# FREDERICK COUNTY PLANNING COMMISSION January 11, 2012

TITLE: Linton at Ballenger: Section II Single

FILE NUMBER: SP 05-08 (AP #12202, APFO #12203

**REQUEST:** Combined Preliminary/Final Site Plan

#### **Exhibit #3 Linton at Ballenger Section II Setback Modification Graphics**

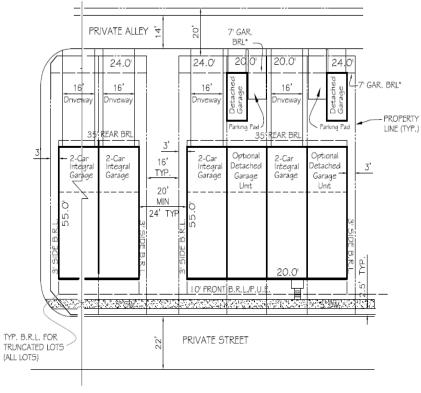
Lots 258-272 Townhomes Rear load Optional Integral/Detached Garage Units: 10foot front and 7-foot rear yards and 3-foot side yards, the 35-foot rear BRL will remain for all integral garage units. Lots 175-184 Single Family Integral/Detached Garage Option Setback optional 15-foot rear BRL for the attached garage version of the single-family detached units.

\*BUILDER HAS THE OPTION TO BUILD AN INTEGRAL 2 CAR GARAGE UNIT OR A SINGLE DETACHED GARAGE WITH SINGLE PARKING PAD. WHERE PROPOSED ARCHITECTURE REFLECTS A DETACHED GARAGE, A 7' REAR GARAGE BRL SHALL BE MAINTAINED.
